Subject: Response to Administratively Incomplete Determination Part A and General Part B of the Resource Conservation and Recovery Act (RCRA) Permit Renewal Application Los Alamos National Laboratory EPA ID#NM0890010515, HWB-LANL-20-001

**Response to Administratively Incomplete
Determination Part A and General Part B of the
RCRA Permit Renewal Application Los Alamos
National Laboratory EPA ID#NM0890010515,
HWB-LANL-20-001**

Figure 1.

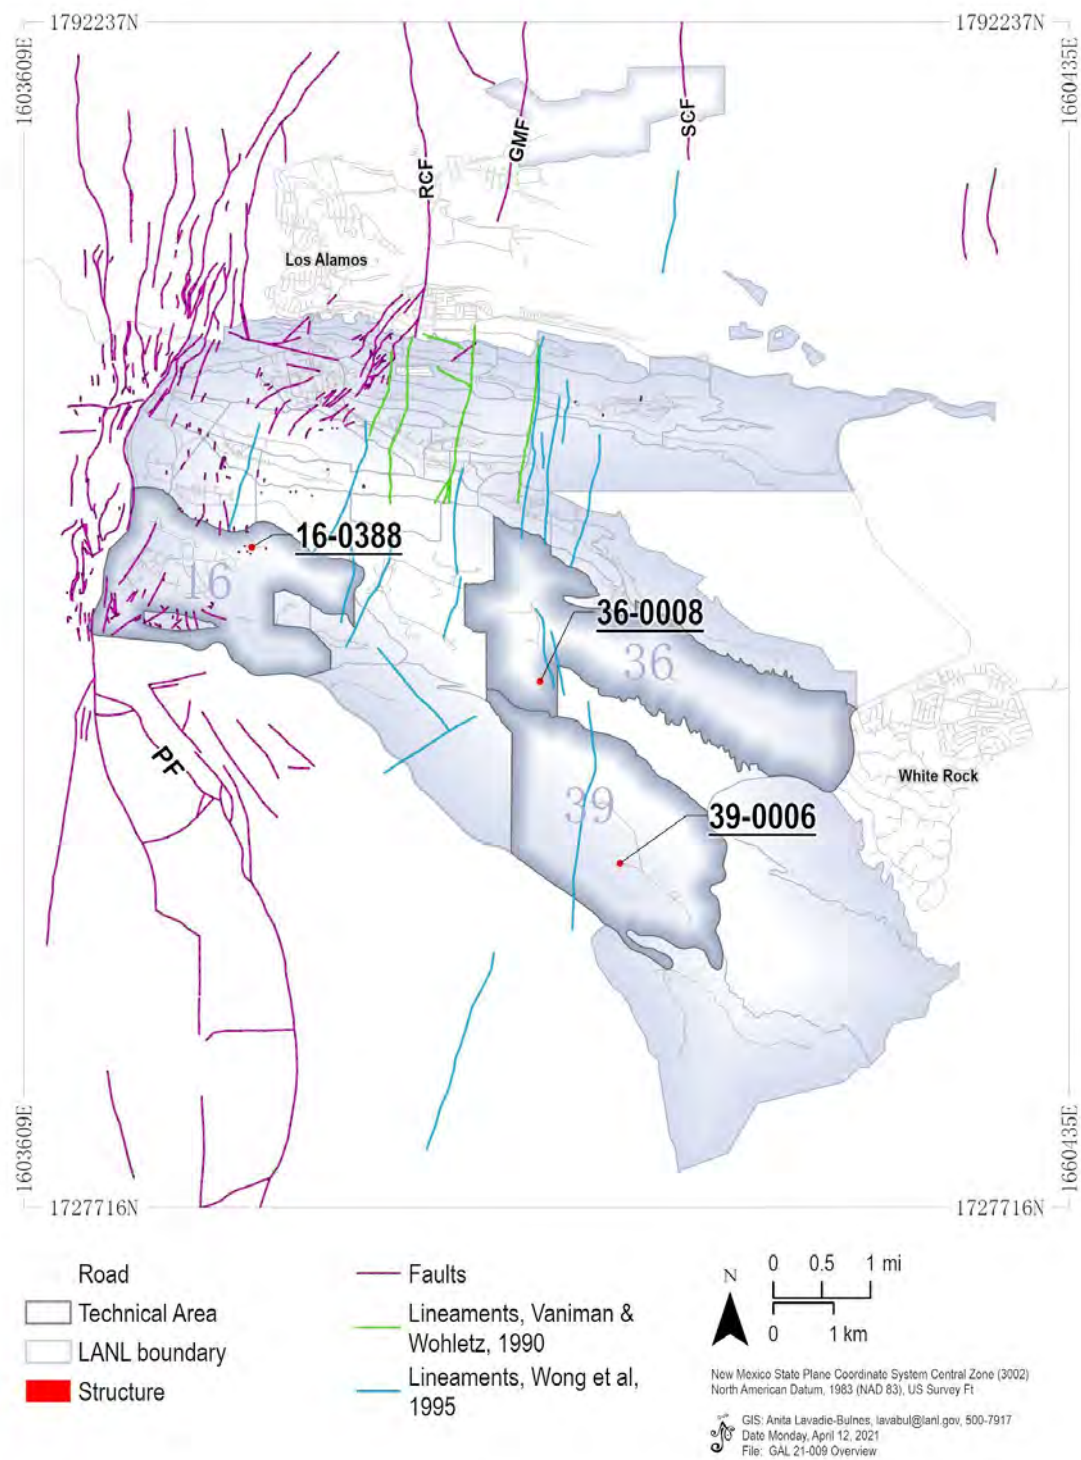
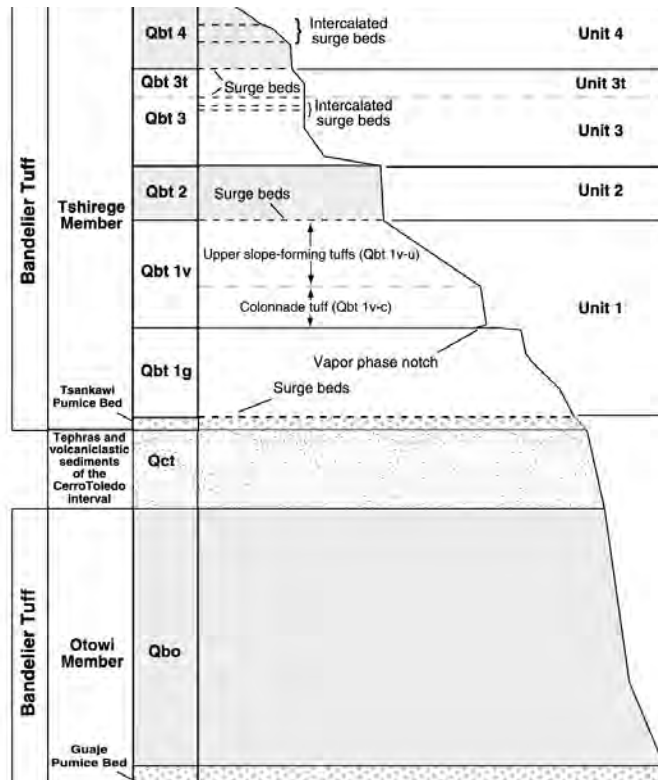
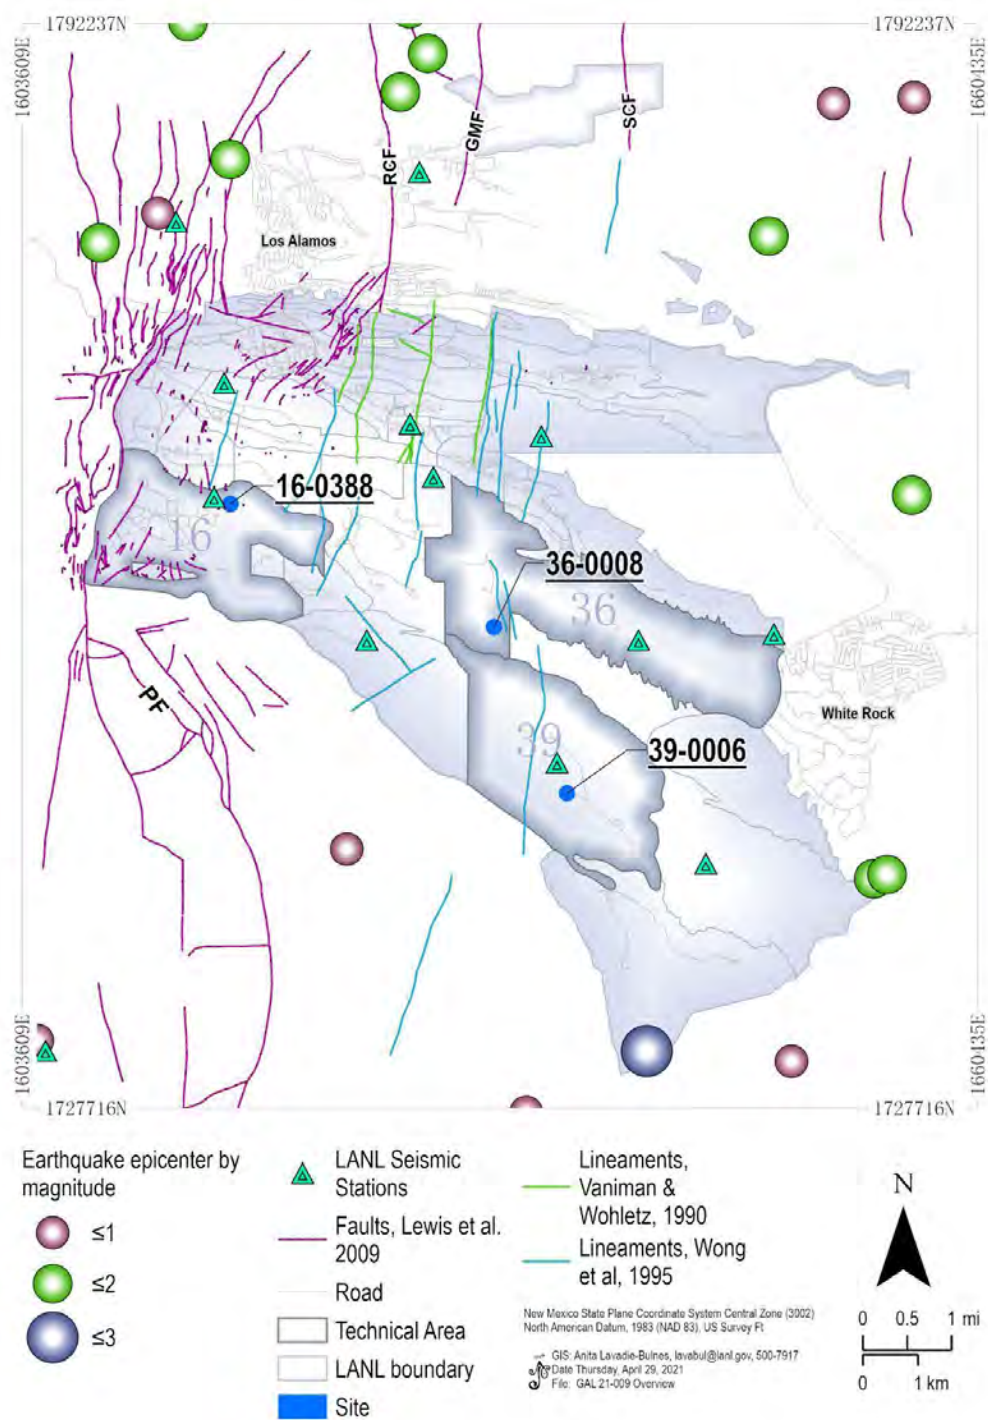
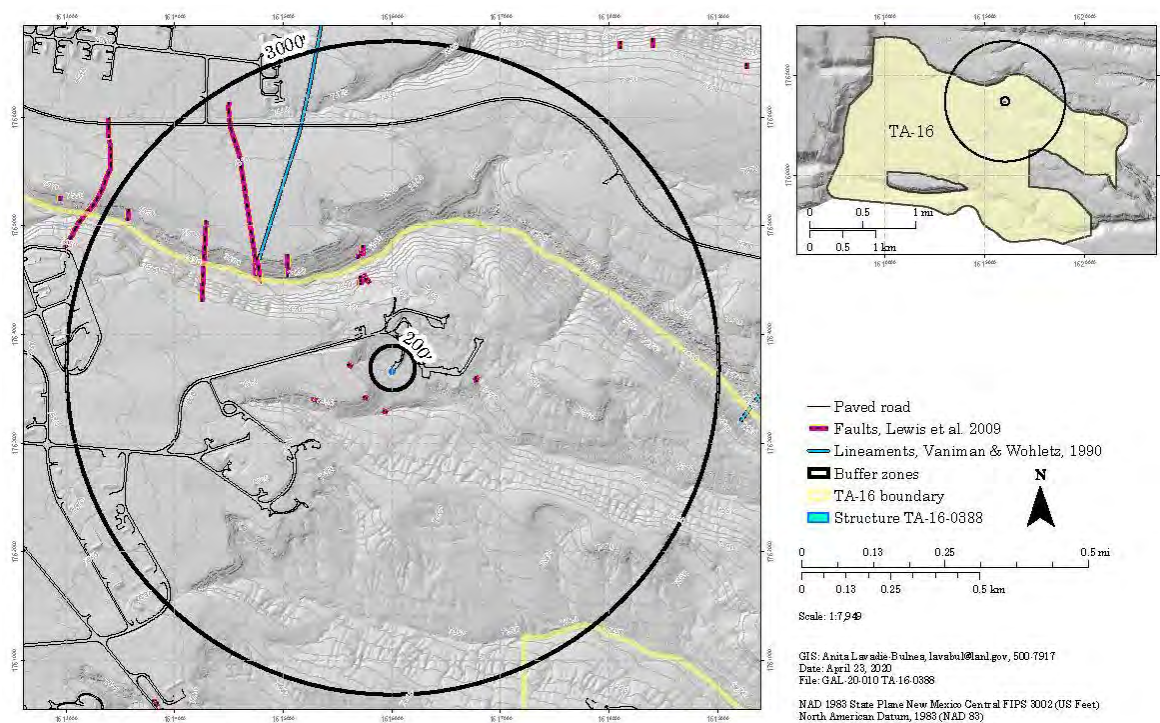
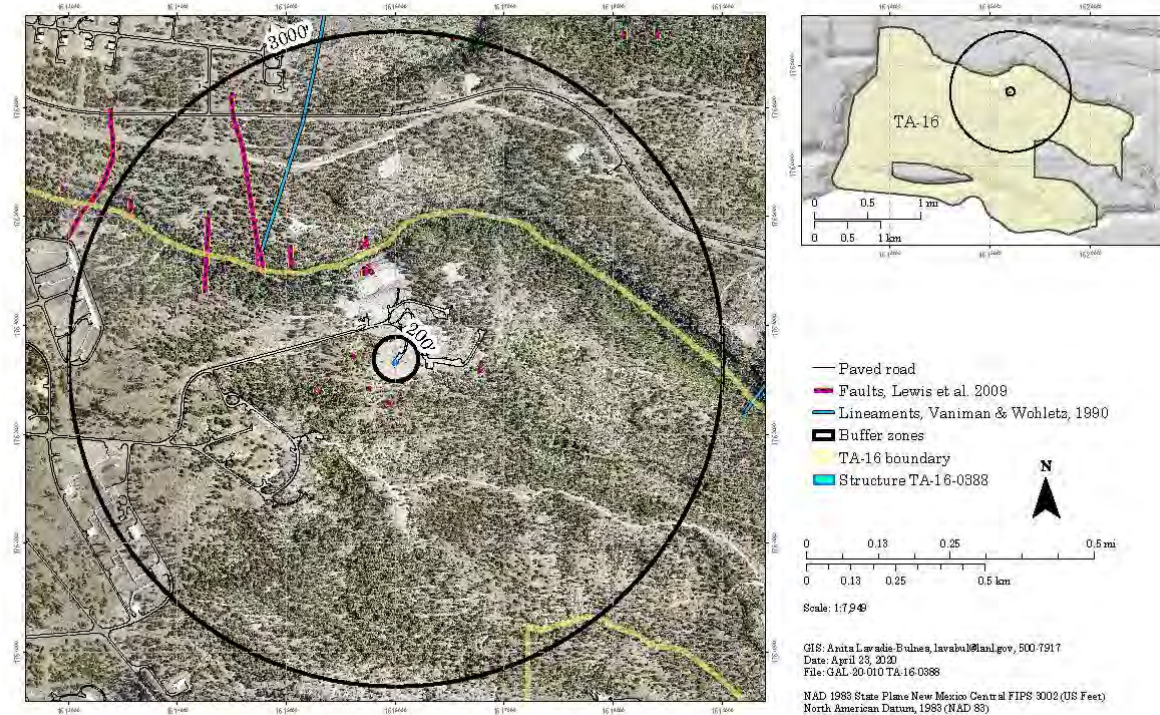
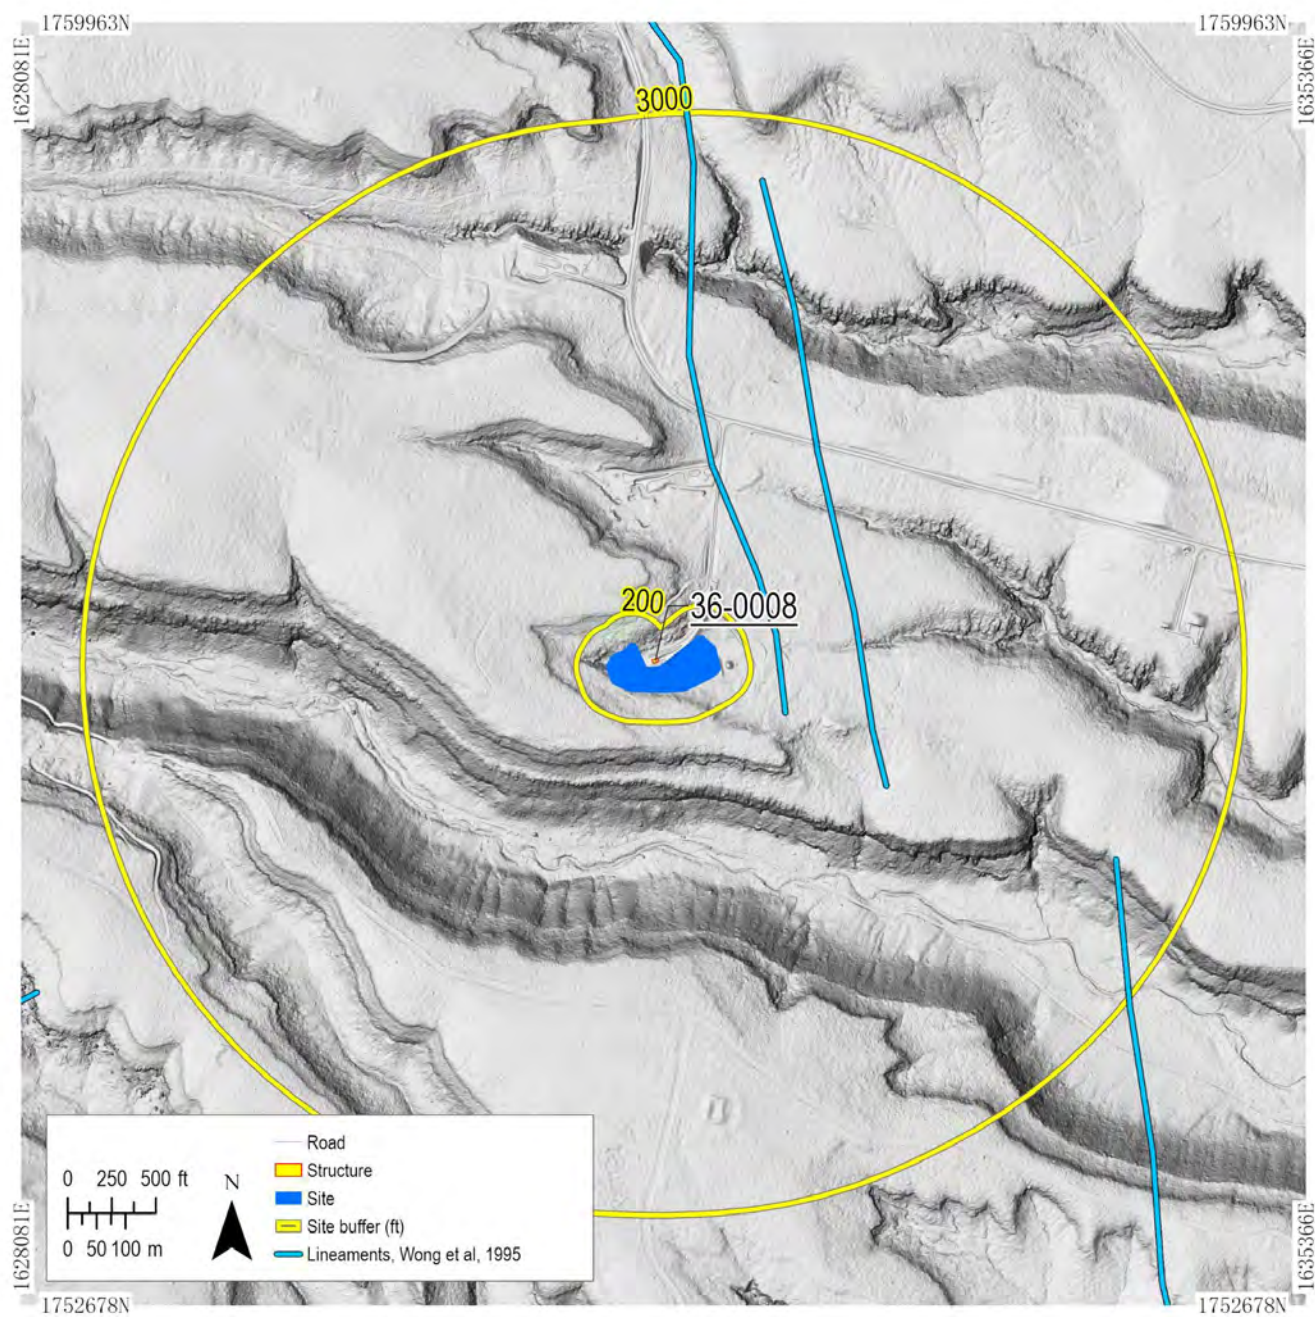
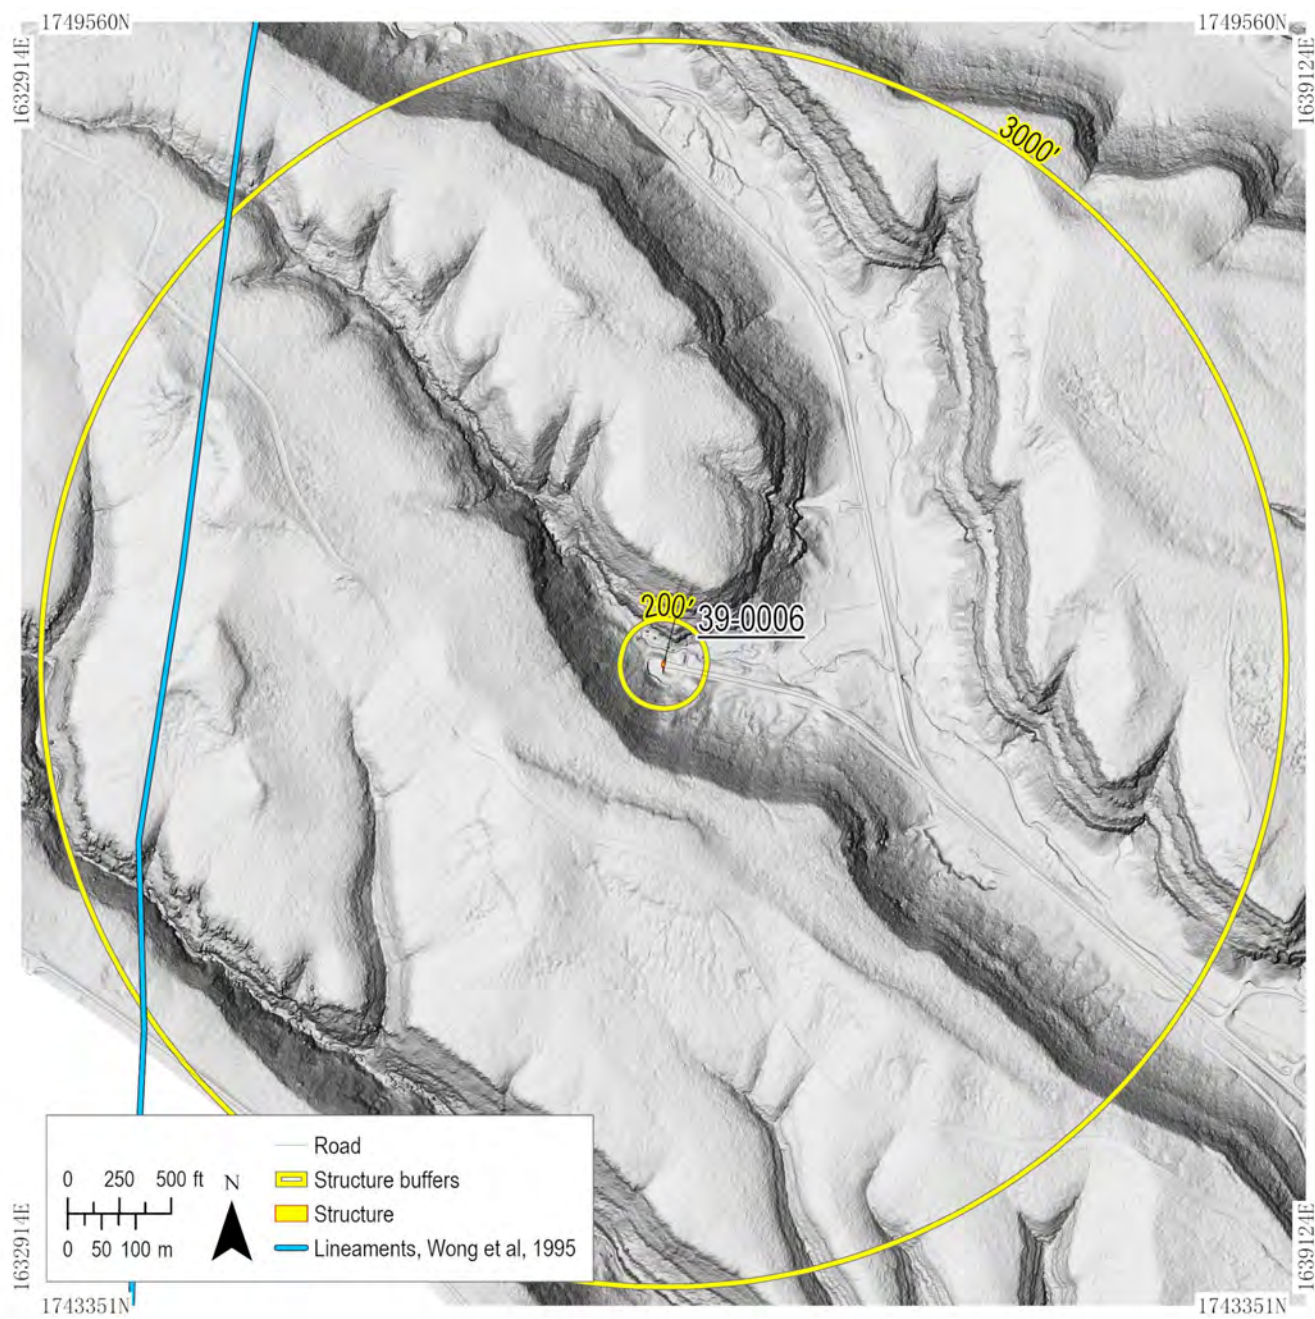
Appendix VI of 40 CFR 264, therefore, the Permittees must provide geologic data which demonstrates compliance with the seismic standard (see 40 CFR 270.14 (b)(11) for more information). The Permittees must provide seismic information for the three (3) waste treatment units proposed to be included in the permit (i.e., Technical Area (TA) 16-388, 36-8, and 39-6).

Attachment 3 includes maps and seismic location information for the proposed open burning and open detonation units at TA-16-388, TA-36-8, and TA-39-6. Text reflecting the addition of the seismic location information is added to the Permit Renewal Application Section 2.10.1, *Seismic Standard* in Attachment 4 of this response. Although the seismic investigation included in Attachment 3 demonstrates that there has been no direct evidence observed for Holocene faulting within the required radius of the facility, it is noted within the seismic report that field reconnaissance may be required to confirm the determination, as field activities are delayed due to COVID 19 safety restrictions.

Figure 2-3. Wind Roses (day and night averaged for the 365 days of 2018)

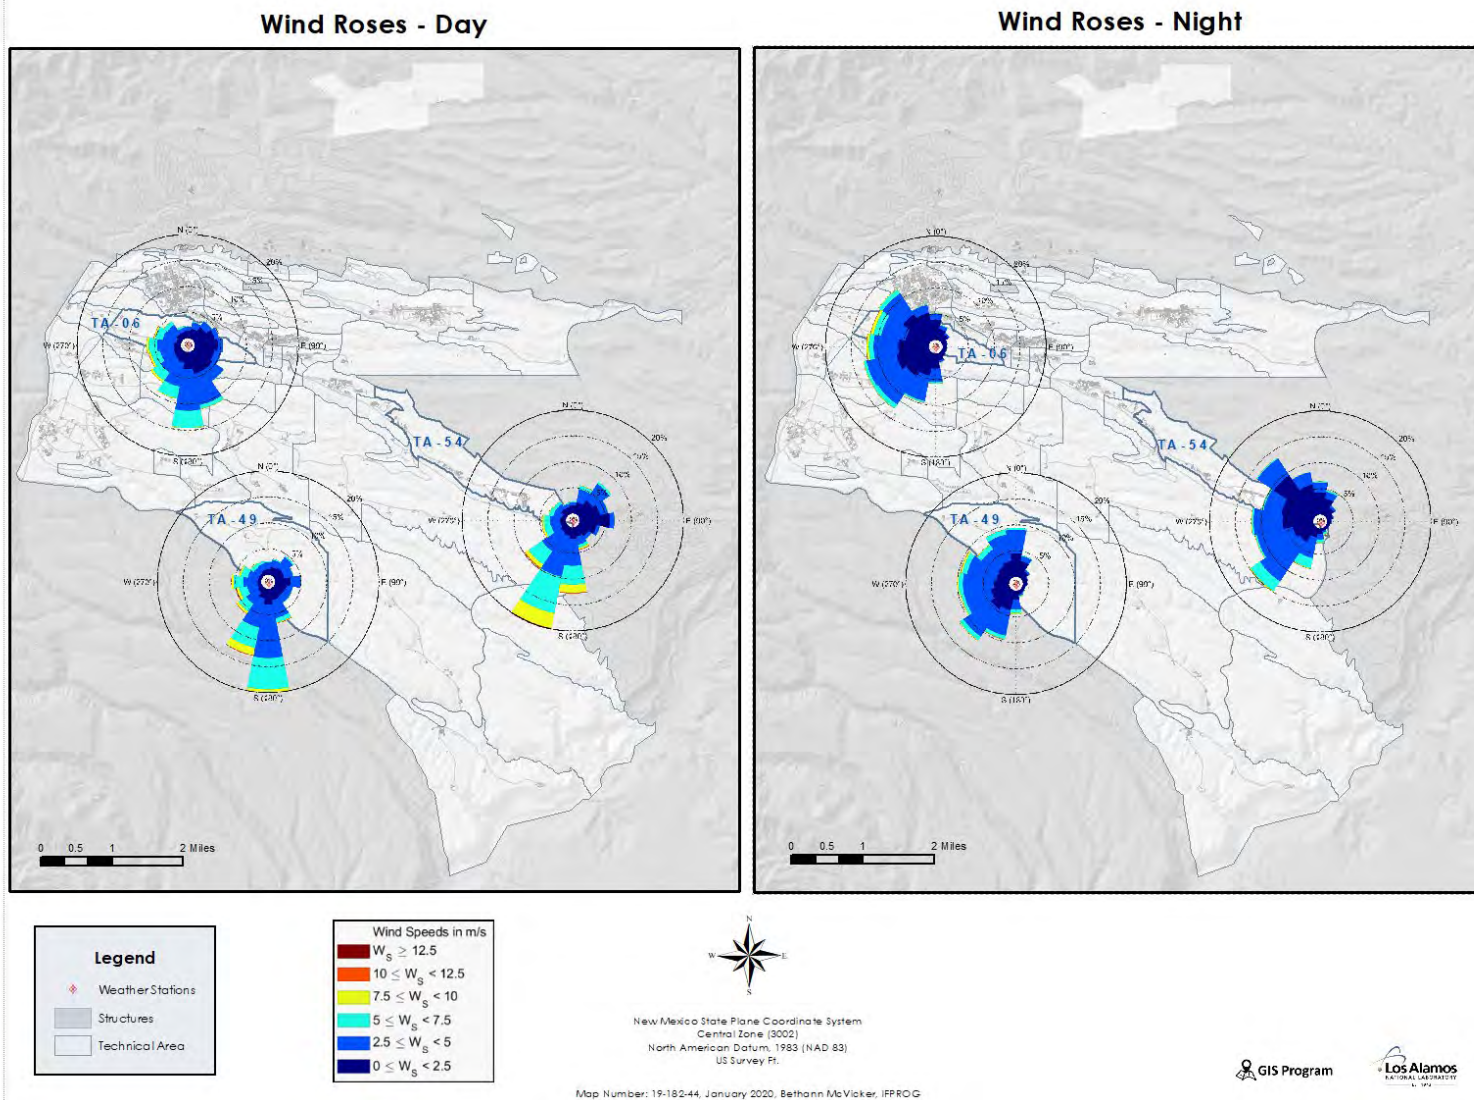
7. Section 2, Figure 2-3 Wind Roses (Day and Night), page 2-24:

The Permittees have not provided adequate information regarding the wind roses referenced in Sections 4, 5, and Supplements 4-3 through 4-9, -12, and -13. It is unclear when the data used to generate these wind roses was collected, and how many total days of data are compiled in the figure (e.g., a single year of data, or the average of five years of data). The Permittees must revise this Application to provide additional details on what year or years are represented by the day and night wind roses. Wind roses appear to have been calculated based on data from meteorological stations distant from the proposed OB/OD units. Please provide a rationale explaining why these monitoring locations are

Permit Renewal Application Figure 2-3 is revised (in Attachment 4) to include the year and total days that the wind roses were based upon. These wind roses were drafted based on winds from all 365 days of 2018. In general, wind roses from different years are almost identical in terms of the distribution of wind directions, indicating that wind patterns are constant when averaged over a year. As detailed in the Los Alamos Climatology 2016 Update (<http://permalink.lanl.gov/object/tr?what=info:lanl-repo/eprr/ESHID-602502>), there are four meteorology towers on the mesa tops at LANL at TA-6, TA-49, TA-53, and TA-54. The TA-53 location was not included in the Permit Renewal Application figures because it was deemed to be too far from any of the hazardous waste management units within the Permit or units in interim status. The other three meteorology towers are included in the Permit Renewal Application because they are the closest towers to the permitted and interim status hazardous waste management units. The distance for the TA-6 tower to the interim status units is: TA-36-8, ~4.26 miles; TA-39-6, ~5.5 miles; and TA-16-388, ~1.4 miles. The distance from the TA-49 tower to the interim status units is: TA-36-8, ~1.13 miles; TA-39-6, ~2 miles; and TA-16-388, ~3 miles. For completeness and comparison, the day and night 5-year averaged wind roses for 2016 through 2020 are included as Attachment 5 of this response. The 5-year wind rose data further illustrate that the wind rose information for each of the towers demonstrate very little difference with the exception of the 2018 wind roses that show slightly more intense winds over the single year average compared to the 5-year average.
